DART AEROSPACE LTD		Work Order:	75788
Description: Crosstube Assembly (205/212/412 High Fwd)		Part Number:	D212-664-141
Inspection Dwg: D212-664-141 Rev: D		Page 1 of 1

DRAWING NO. D212-664-141	TITLE XTUBE ASSY (205/212/412 HI FWD)	REV. D	DART AEROSPACE LTD ENGINEERING ORDER		D.E.O. NO. D212-664-141-D-1	SHEET NO. SHEET 1 OF 2	SCALE NTS
DRAWN	CHECKED	MFG. APPR.	APPROVED	DE APPR.			
DATE 11.04.07	DATE 11.04.11	DATE 11.04.12	DATE 11/04/12	DATE 11.04.12

ADD AN INSPECTION WINDOW TO UNDERSIDE OF CROSSTUBE.

REPLACE MAGNOBOND WITH PROSEAL.

**D212-664-141/-141B
ASSEMBLY DETAIL**

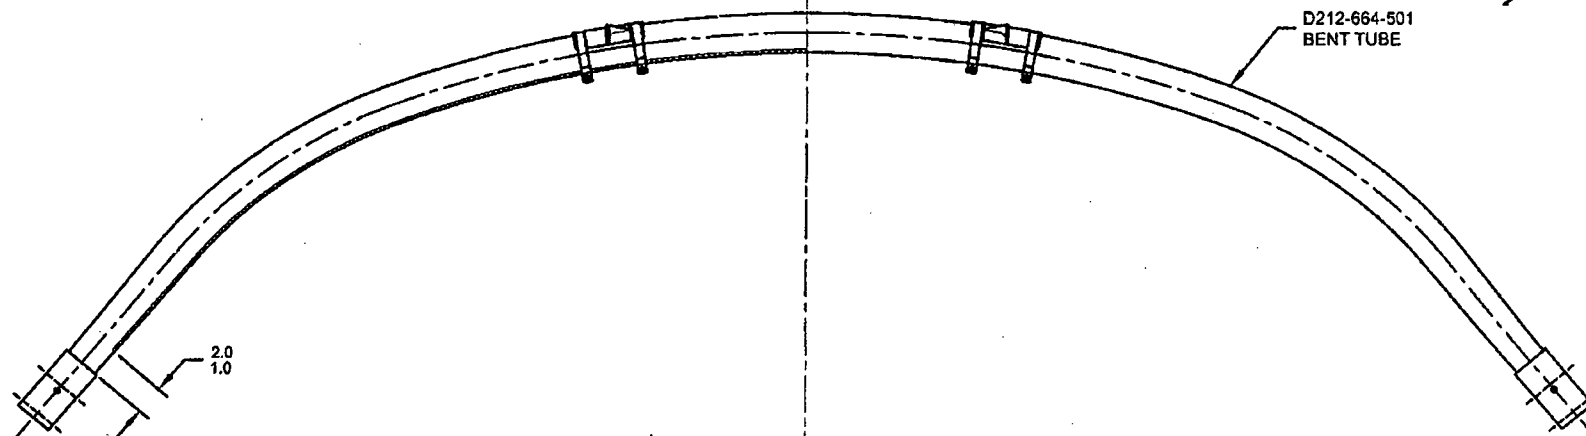
NOTES 2 OF SHEET 1 IS AMENDED AS FOLLOWS:

- 2) FINISH: CHEMICAL CONVERSION COAT PER DART QSI 005 4.1
 PRIME INSIDE AND OUTSIDE PER DART QSI 005 4.2
 MASK UNDERSIDE OF CROSSTUBE AS SHOWN (HATCHED AREA) AND
 PAINT OUTSIDE PER DART QSI 005 4.2
 REMOVE MASKING AND APPLY CLEAR COAT

MASK AREA PRIOR TO PAINTING,
REMOVE MASKING AFTER PAINT
AND APPLY CLEAR COAT
